SAFETY INFORMATION

1/92

RESERVE LINE STOWAGE

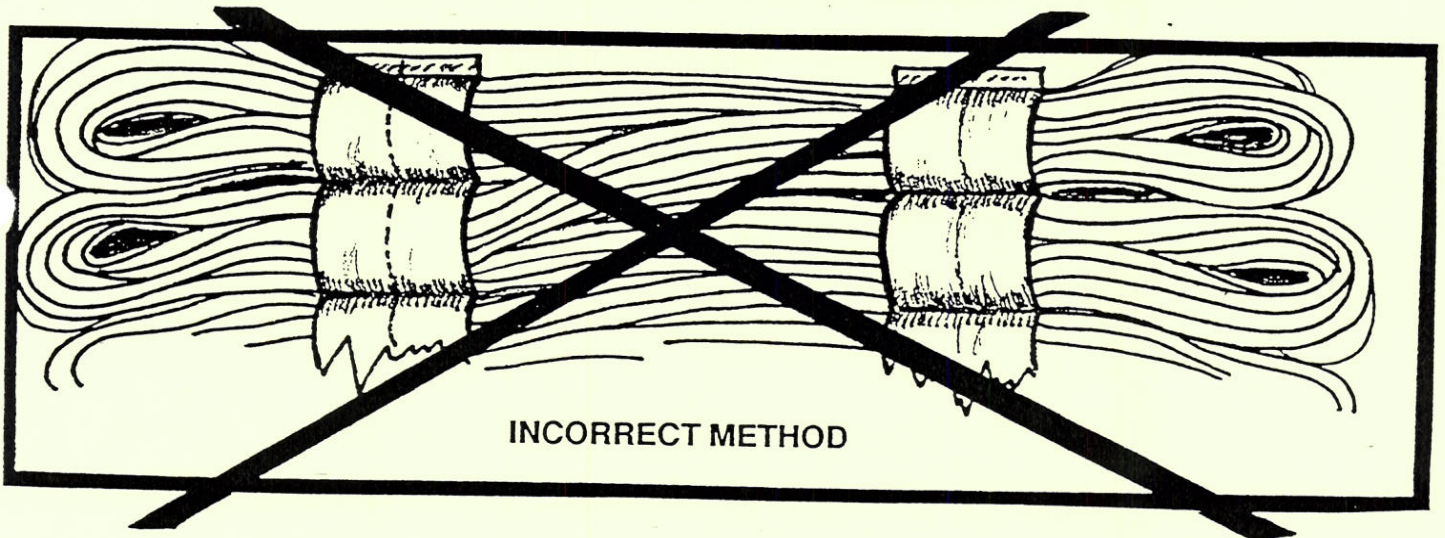
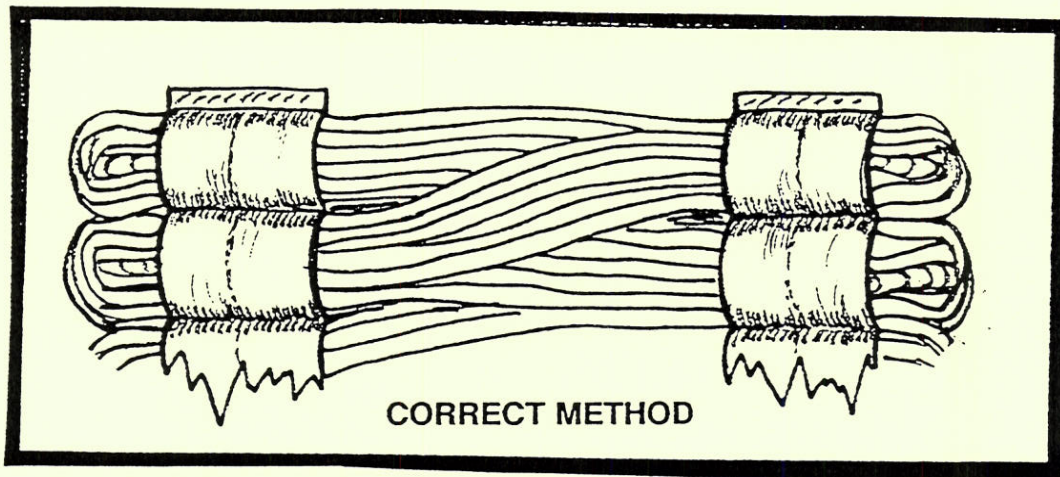
There has been a report of a 'line lock' on a Parachutes De France reserve free bag, caused by incorrect line stowage.

Below is the correct and incorrect method of stowing the lines.
